## **Town of Arlington, MA Redevelopment Board**

### **Agenda & Meeting Notice July 6, 2020**

##### **Docket #3602, 1207-1211 Mass Ave**

##### **Docket #3625, 882-892 Mass Ave**

9:00 AM

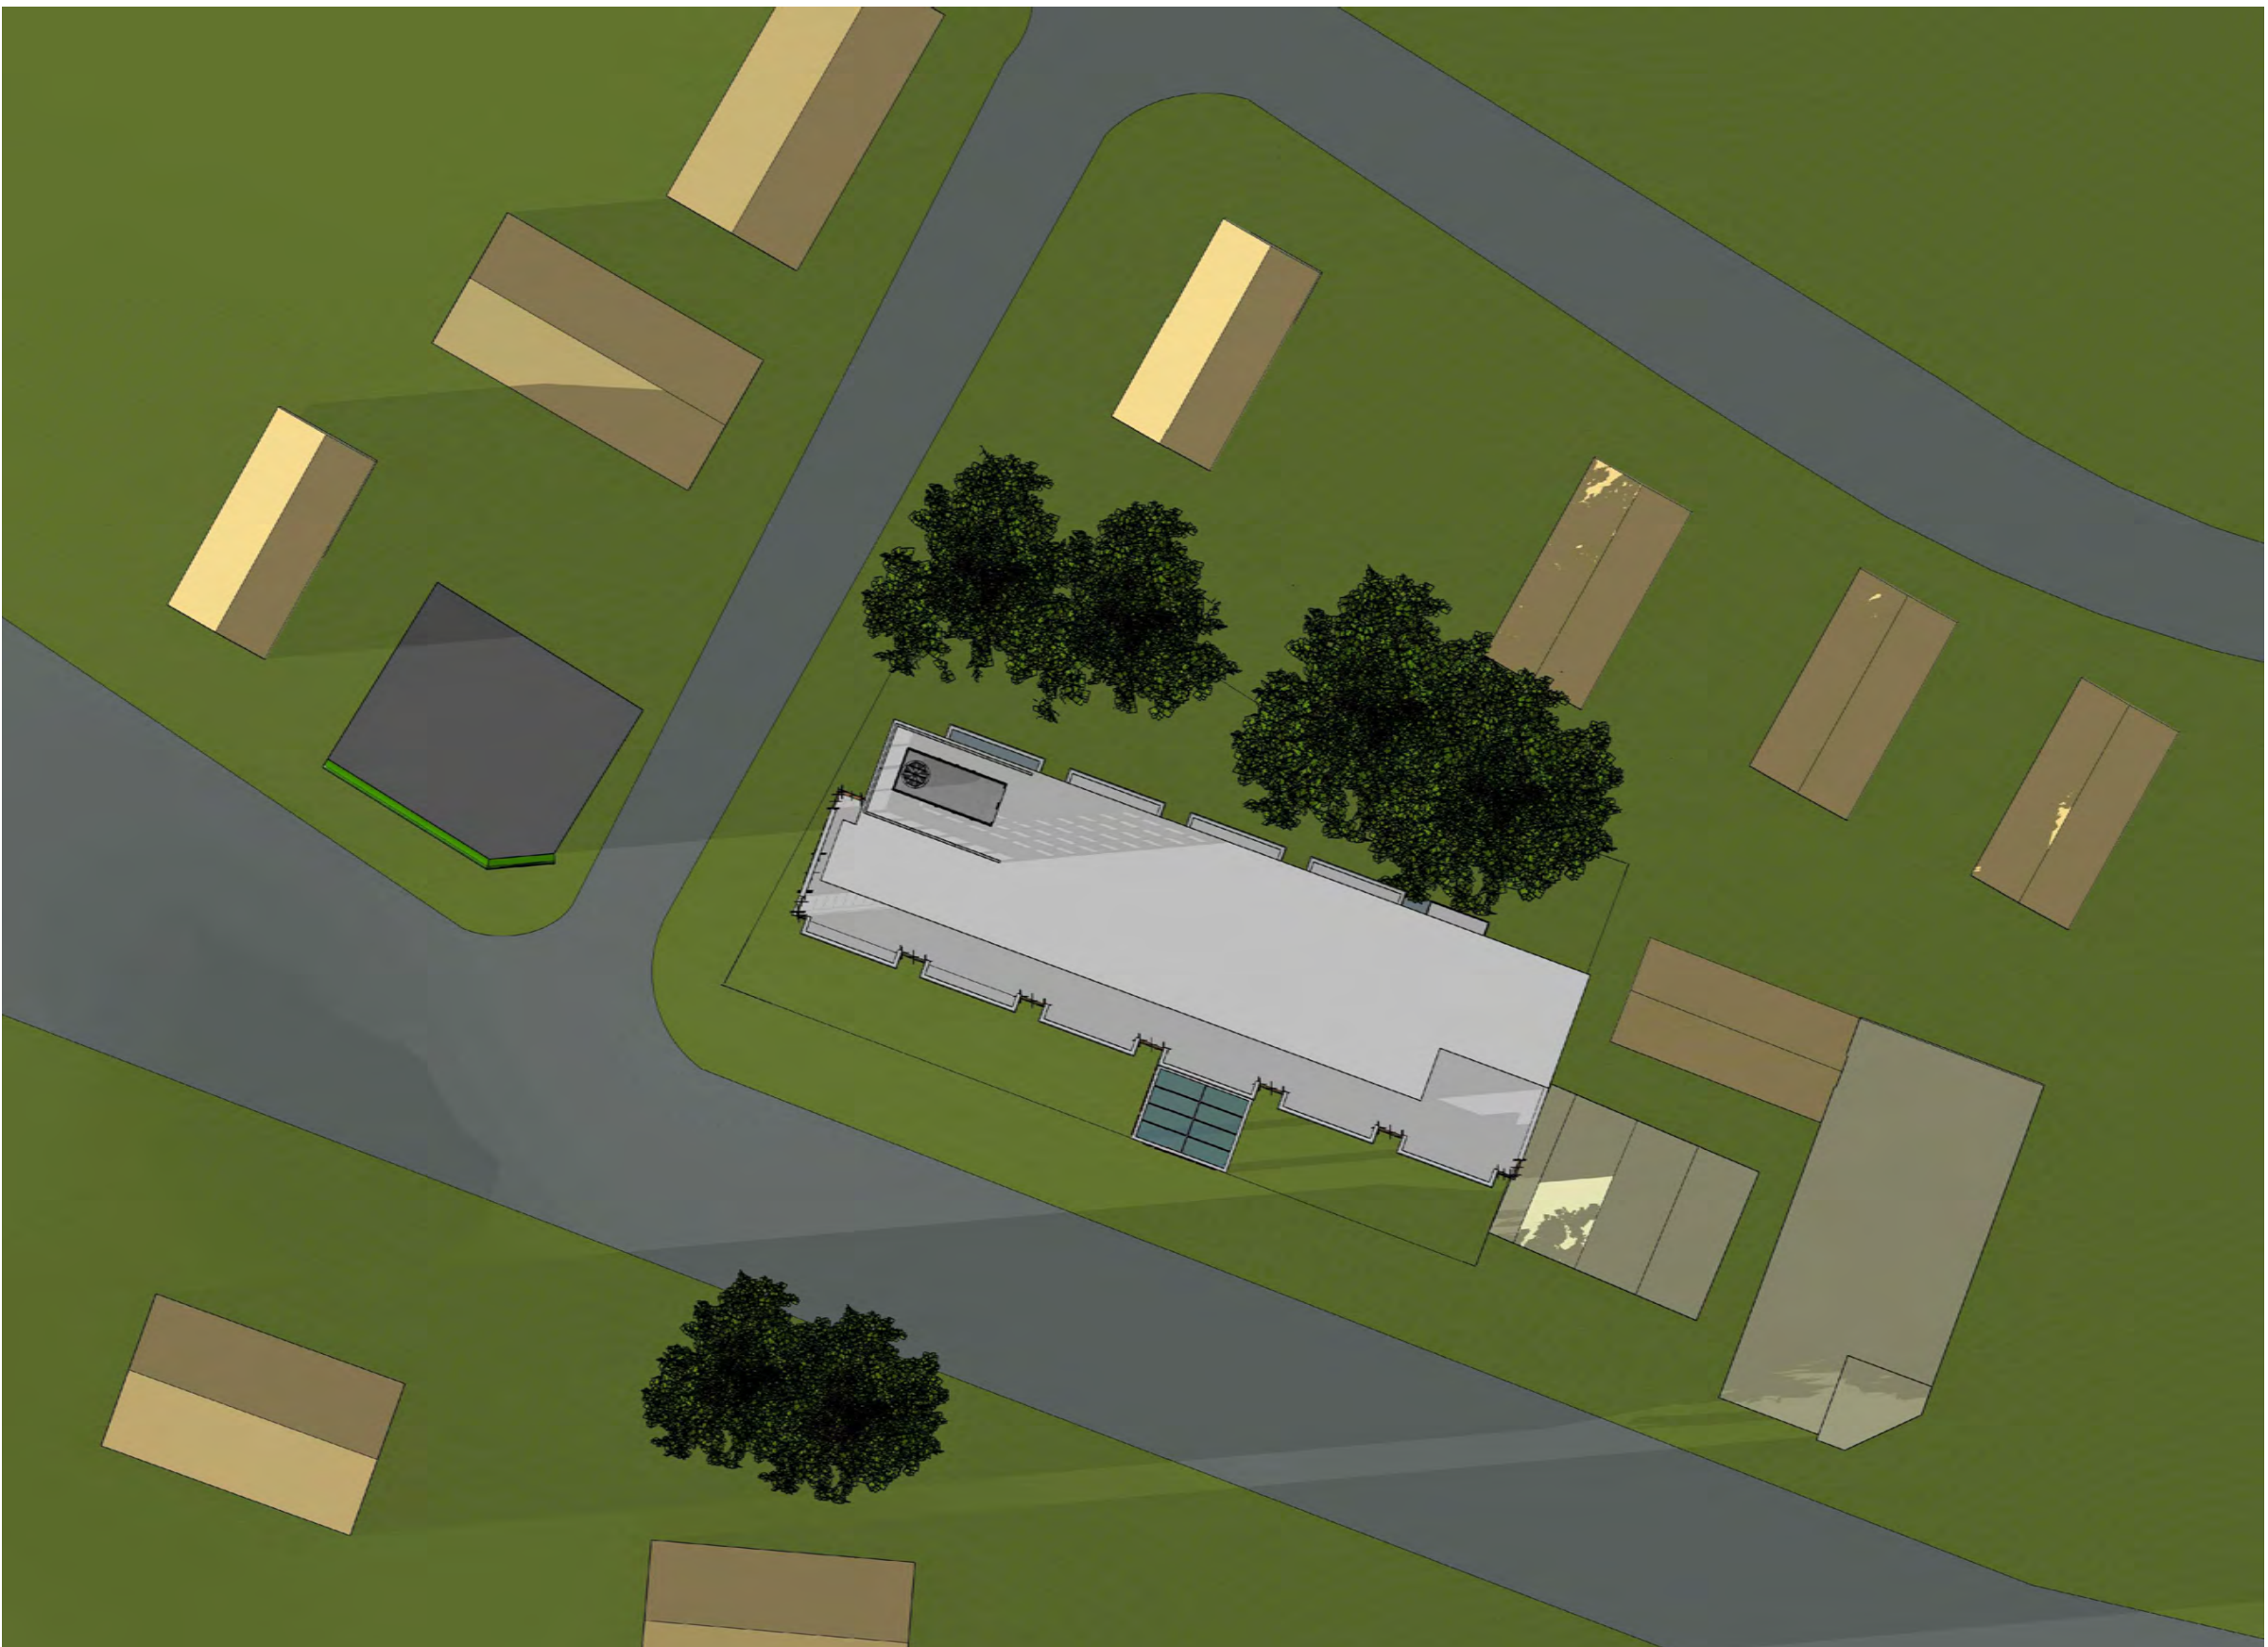
7. Re-evaluate the shadow study previously submitted to consider the existing shadows and provide a comparison and determine any impact to solar arrays in the neighborhood.

7. Take another look at your shadow study, consider the existing shadows and provide a comparison and determine any impact to solar arrays in the neighborhood;

*The plan set includes an updated shadow study based on the new building. The plan set also includes a shadow study documenting the existing conditions of the building and shows trees at the rear of the site.*

*The plan set includes an updated shadow study based on the new building. The plan set also includes a shadow study documenting the existing conditions of the building and shows trees at the rear of the site. The updated materials do not identify if any of the adjacent buildings have solar arrays installed.*

SITE PLAN LIGHTING- PHOTOMETRIC PLAN  
Scale: 3/32" = 1'-0"

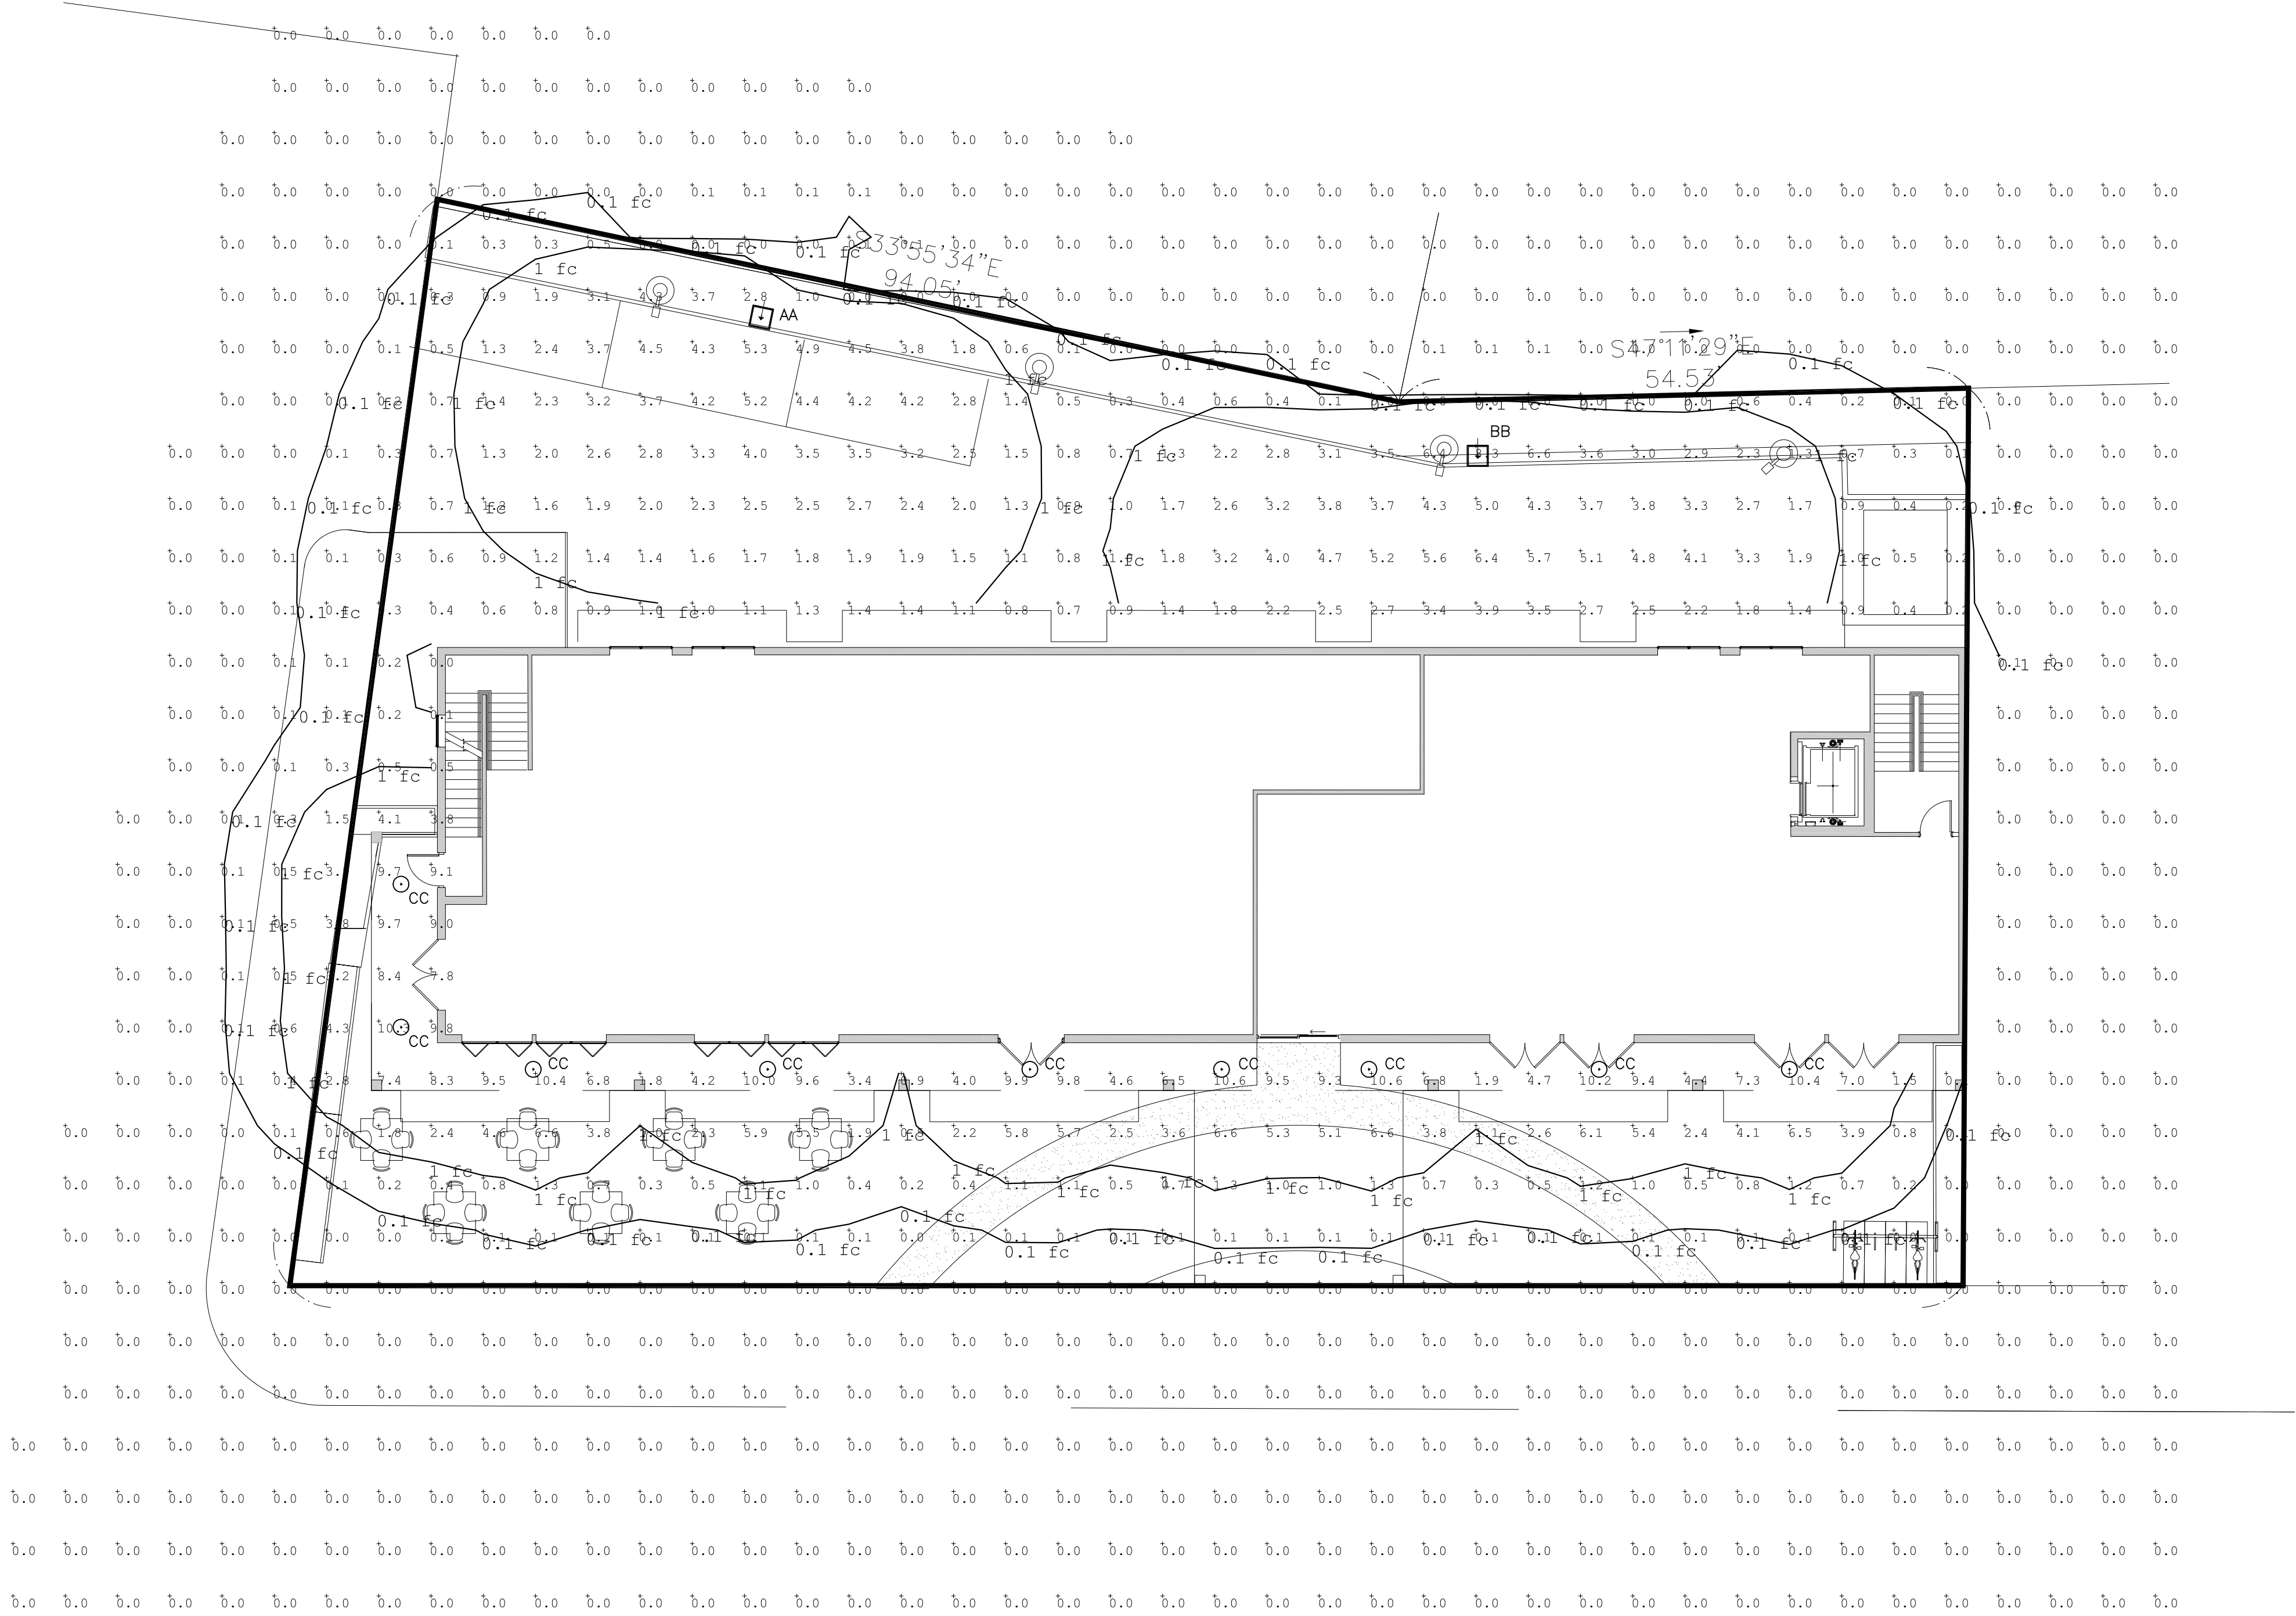
17. Provide more details on the proposed lighting.

*Attorney Winstanley-O'Connor's memo notes that the lighting will be energy efficient LED low profile lighting. Deflectors and other technology will be utilized, and a photometric study will be prepared prior to installation. The ARB may desire to see that photometric plan as well as lighting specifications to understand the type of fixtures to be used for the proposal and how it may or may not impact abutters.*
